ND NORSK DATA	ENGINEERING CHANGE ORDER		PAGE 1 OF 4.
			ECO NO.: 100-781
VALID FOR	PART NOS. : 324911 VERSIONS : CA NAME : COMSON DISKBOARD SCSI PRINT NOS.: 5911 ND NOS. : --		
NEW VERSION	PART NOS. : 324911 VERSIONS : DA NAME : COMSON DISKBOARD SCSI		
SYMPTOMS	<u>FATAL:</u> Overwriting on SCSI-devices or transfer error.		
COMPO- NENTS  Resistor	REMOVE:	INSERT:  2 pc. 330 ohm (p/n 503020)	
VALIDITY	X      EQUIPMENT IN PRODUCTION X      FUTURE PRODUCTION * *    FIELD ACTION		
RESPONS- IBILITY	APPROVED BY: TAB/MIB _____ DATE:            910606 _____	REVISION:            _____ ISSUED BY:            _____ DATE:                _____

ND NORSK DATA	ENGINEERING CHANGE ORDER	PAGE 2 OF 4.
PART NO.: 324911 CA > DA		ECO NO.: 100-781
ISSUED	DATE: 910605	BY (INITIALS): AMA

NORSK DATA A. S. OSLO NORWAY	
	ID NO: 324911 C A2 PRINT: 5911 A2	SHEET 1 OF 4
DESIGN: ERIK DRAWN: EHL DATE: 1 87.07.82		
COMSON DISKBOARD 6CSI PLUG A PLUGS J7, J11, J12, J15		
REVI:

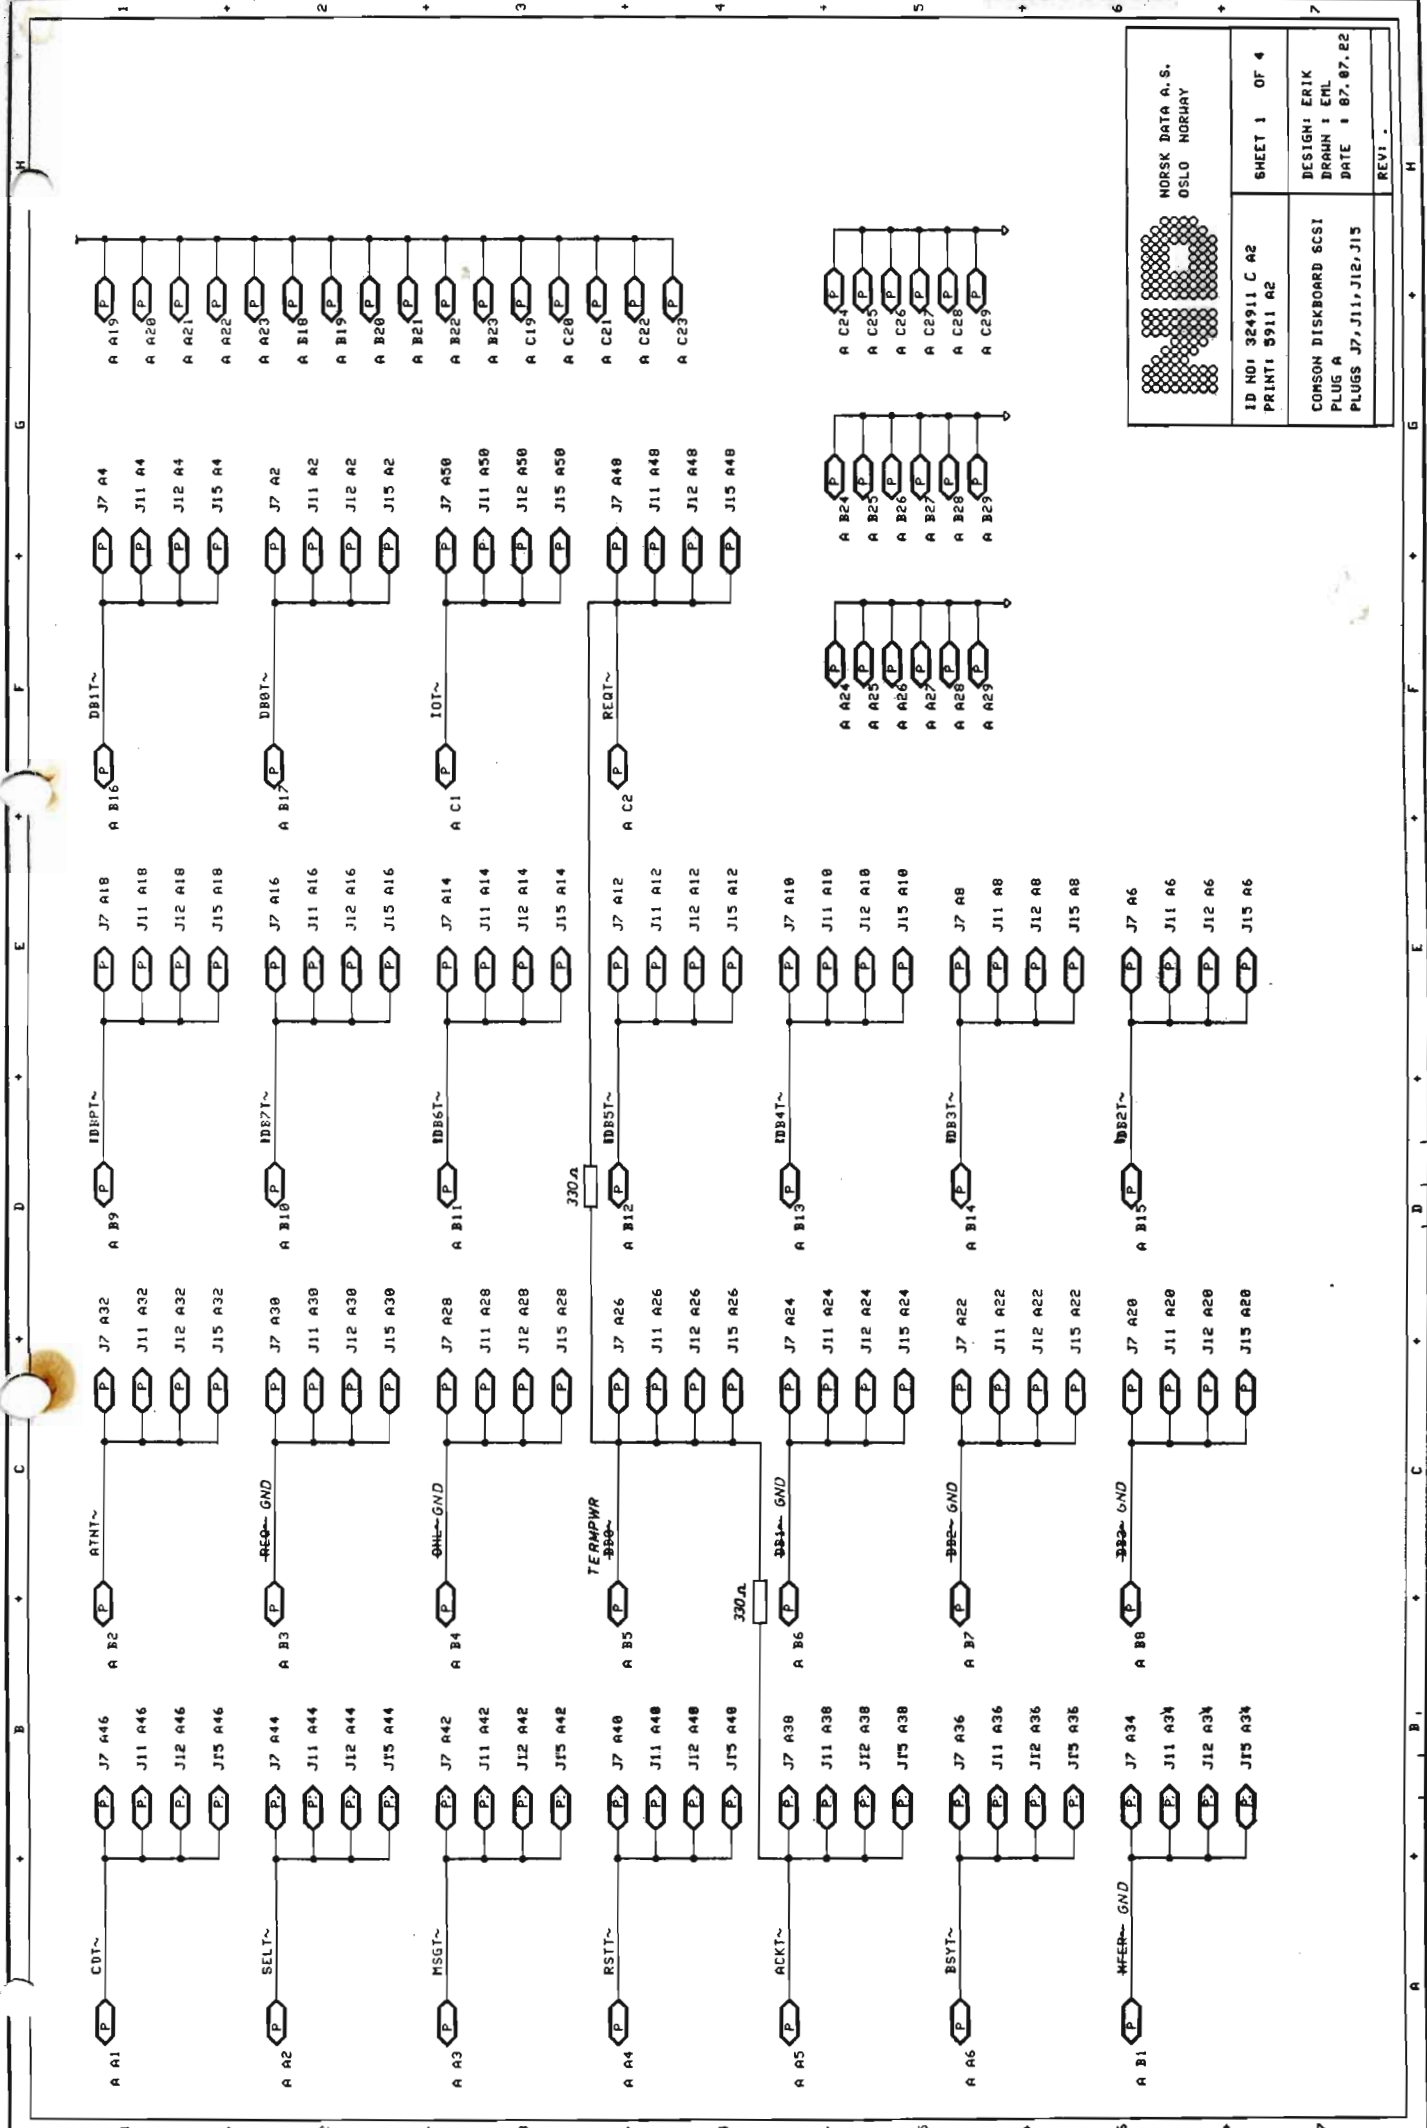
Insert 2 pc. 330 ohm resistors as shown on arrangement drawing.

It should be between REQ1-0 (J7/a48) and TERMPWR (J7/a26)  
and between ACK1-0 (J7/a38) and TERMPWR (J7/a26)
